**Optimization Review
Bunker Hill Mining and Metallurgical Complex
Superfund Site
Central Treatment Plant (CTP)**

Kellogg, Shoshone County, Idaho

Report of the Optimization Review
Site Visit Conducted at the Bunker Hill Mining and Metallurgical Complex Superfund Site
April 19, 2012

July 31, 2013

Figure 2-1
Central Treatment Plant and
Related Features
BUNKER HILL SUPERFUND SITE
 EPA

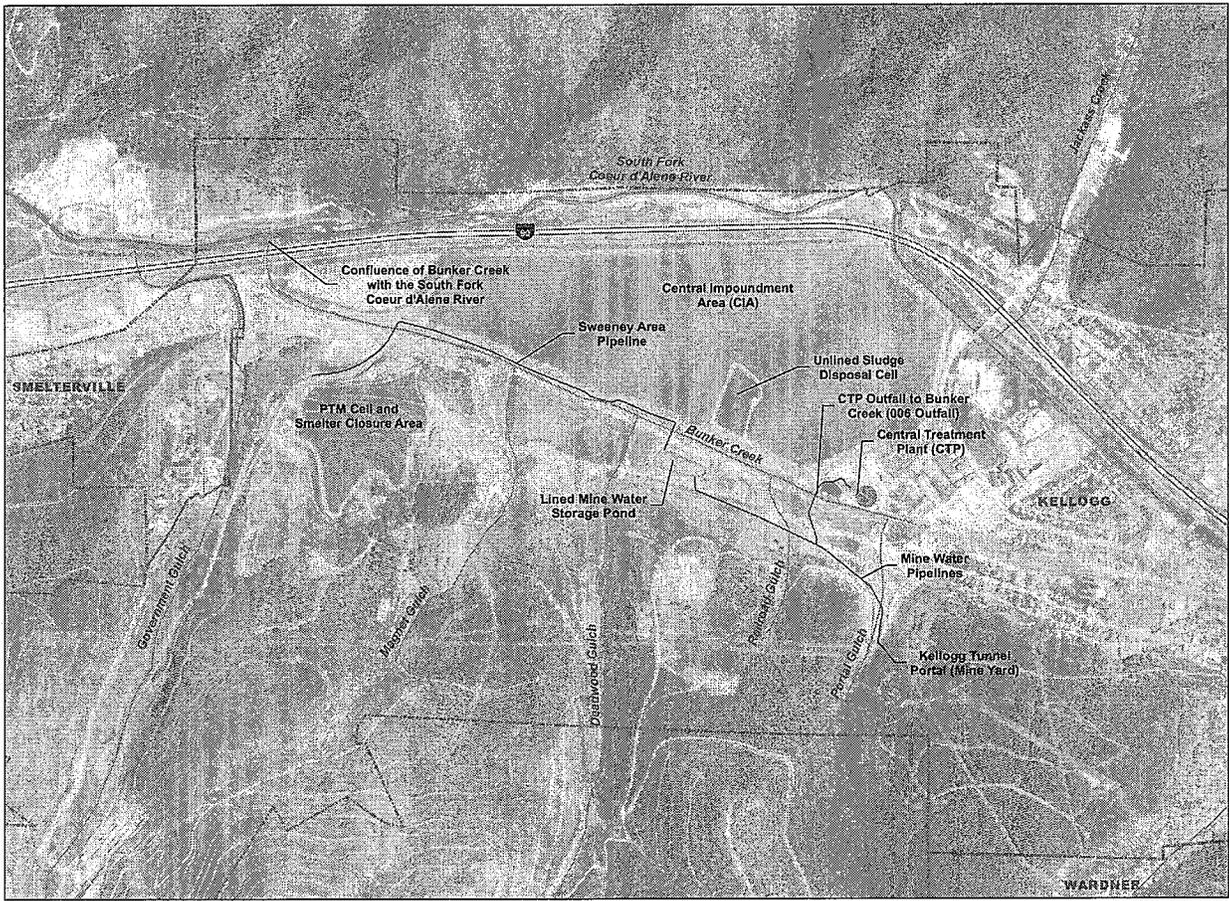
The CTP, CIA, Kellogg Tunnel portal and other CTP-related features are shown in Figure 2-1 (see Attachment A). These features include the principal threat materials (PTM) cell and smelter closure area, Sweeney Area Pipeline (water collection and conveyance), lined pond (for flow equalization and side-stream storage) and unlined sludge disposal cell (lagoon).

Figure 5-2
Bunker Hill CTP Flow Sheet
 BUNKER HILL SUPERFUND SITE

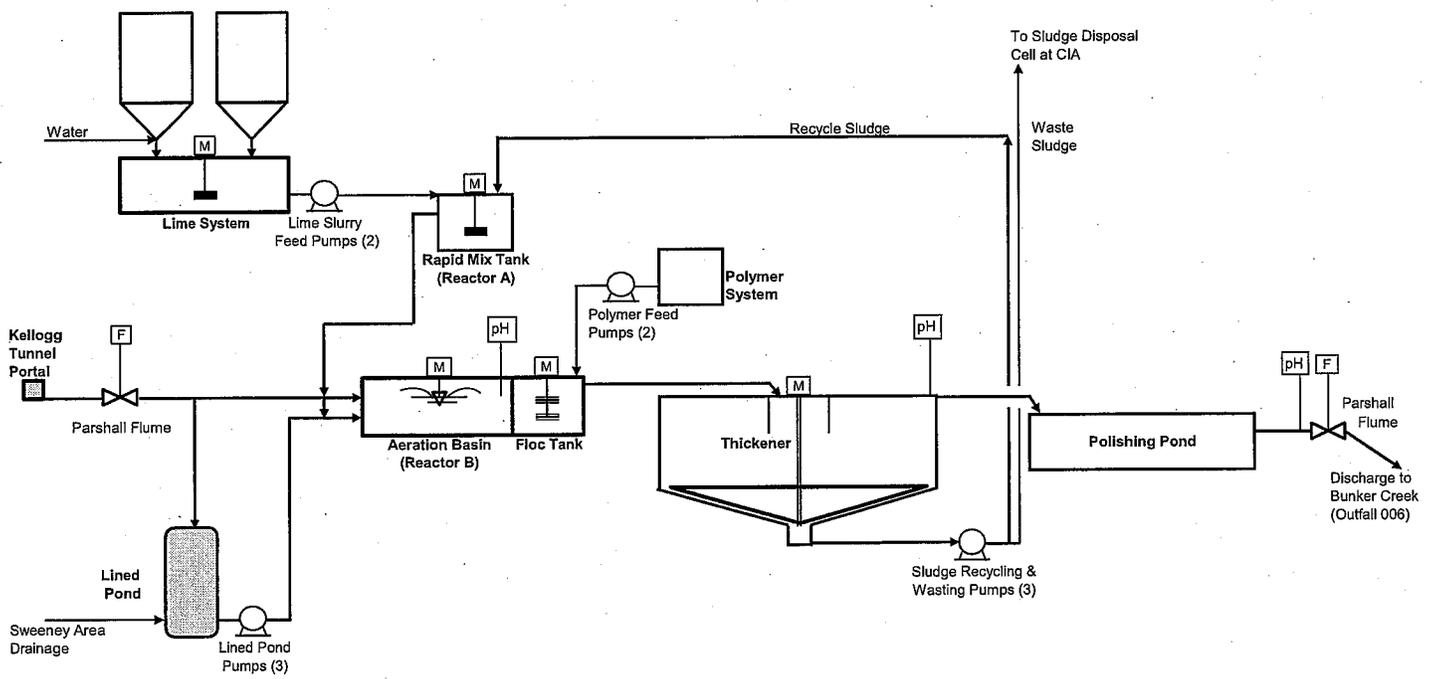
The CTP flow diagram is shown in Figure 5-2 (see Attachment A). The CTP facilities include lime feed and polymer feed pumps, a rapid mix tank (Reactor A), aeration basin (Reactor B), flocculation (floc) tank, thickener, sludge recycling and wasting pumps, a polishing pond, flow measurement equipment and discharge pipes and pumping to Bunker Creek.

The rapid mix tank (Reactor A) receives only the recycled sludge from the thickener and the lime slurry feed. Plant influent flows directly to Reactor B. Lime slurry feed is intermittent and is controlled by the pH in the second reactor, Reactor B.

The current flow path is limiting the effectiveness of the LDS process in several ways. In Reactor A, or the rapid mix tank, only the recycled sludge from the thickener is treated with the lime slurry. The plant influent bypasses Reactor A, thus influent contaminants must come in contact with the effluent from Reactor A in Reactor B for removal to occur. Reactor B is subject to significant short-circuiting due to the configuration of influent and effluent entry and exit piping, and more importantly, due to the swirling motion imparted in the water by the surface aerator. Much of the influent raw water passes through Reactor B without coming in contact with lime; therefore, it is not effectively treated.

1. Redundancy. Similar to the configuration of the two Reactor B units, providing two Reactor A units will ensure that the plant will not be completely shut down if one Reactor A is out.

2. Better lime dose control. The pH is monitored in Reactor B and lime is added in Reactor A. With only one Reactor A, the flow from Reactor A must be split between the two Reactor B units. If the flow split is not accurate, the Reactor B receiving the lesser flow will experience a drop in pH that may not be effectively satisfied by addition of lime slurry to the common Reactor A. The control system would at best overdose in Reactor A causing higher than needed pH in the Reactor B getting the higher flow proportion. This would result in poor lime dose control and a waste of lime. It would be more efficient to return separated flows to two Reactor A units that have been accurately measured with flow meters, sense the pH in the separate Reactor B units, and adjust the lime dose accordingly for each treatment train.

- Replace the existing rapid mix tank (Reactor A) with a properly designed reactor and mixer.
- Replace the aeration basin (Reactor B) with a new basin, mixer and aeration system.
- Replace the manual polymer feed system with an automatic batching system.
- Replace the remaining older sludge recycle and wasting pumps.
- Add an influent flow meter.

Currently the plant influent is directed to Reactor B which is equipped with a bridge mounted mechanical surface aerator. Lime is added in the rapid mix tank (Reactor A), immediately upstream from Reactor B. Recycle flow from the thickener co-mingles with the applied lime slurry in Reactor A, and then the flow discharges to Reactor B. This is the typical flow pattern for the HDS system, but not for an LDS lime precipitation process. In a typical LDS process, all the influent flow passes through the flash mix tank where it has complete exposure to the lime slurry. Following intensive flash mixing, the coagulated water flows on to the next reactor where longer retention time allows the lime precipitation process to be completed. In the CTP, the surface aerator provides the potential for oxidation of certain metals to further enhance the removal efficiency.
